PRODUCT CHANGE NOTICE

PCN# 16-019**NOTIFICATION DATE: March 29, 2016****MODEL(S) AFFECTED:****ROS-2650+ & ZX95-2650-S+****EXTENT OF CHANGE:**

Figure 3: Sens. @ Nom Vcc [MHz/V] vs. Vtune [V] at +25°C

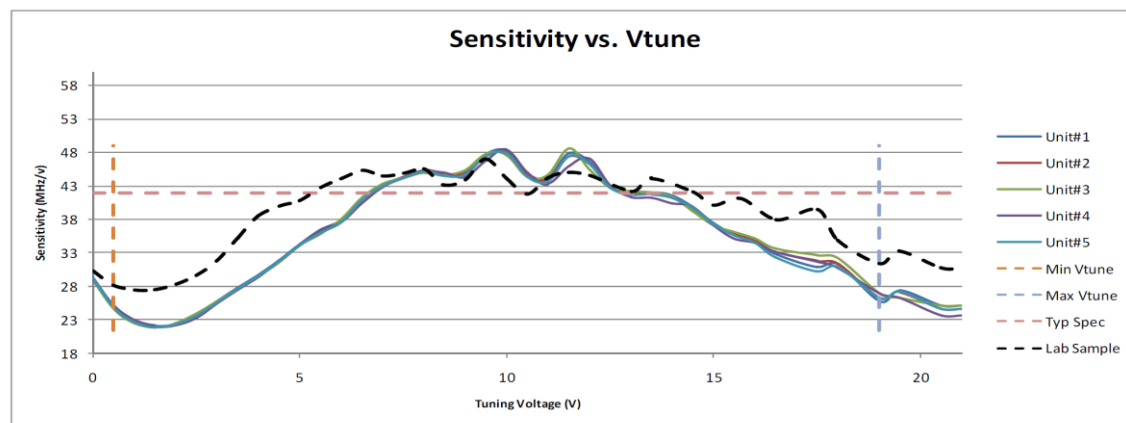
1. Replacement of supplied transistor and varactor diode based on discontinuation of supply with alternate, qualified components.
2. Slight changes of additional internal components to support item 1 and repeat historical performance.

Slight change in Function - performance differs from original performance as follows:
